**PCN#20250608002.2**

**Qualification of CDAT as an additional Assembly/Test site for the Select Devices  
Change Notification / Sample Request**

**Date:** June 09, 2025

Sample product shipping label (not actual product label)

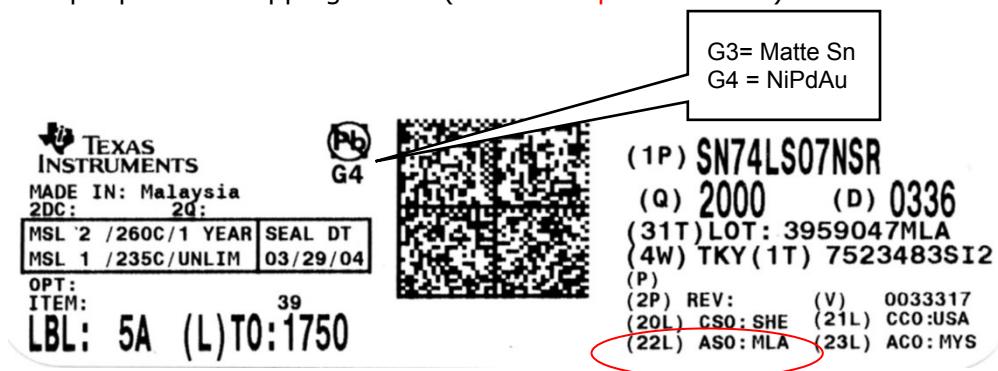
## Changes to product identification resulting from this PCN:

Assembly Site	Assembly Site Origin (22L)	Assembly Country Code (23L)	Assembly City
HFTF	HFT	CHN	Hefei
HNA	HNT	THA	Ayutthaya
TFME	NFM	CHN	Economic Development Zone
UTL2	NS2	THA	Bangpakong, Chachoengsao
<b>CDAT</b>	<b>CDA</b>	<b>CHN</b>	<b>Chengdu</b>
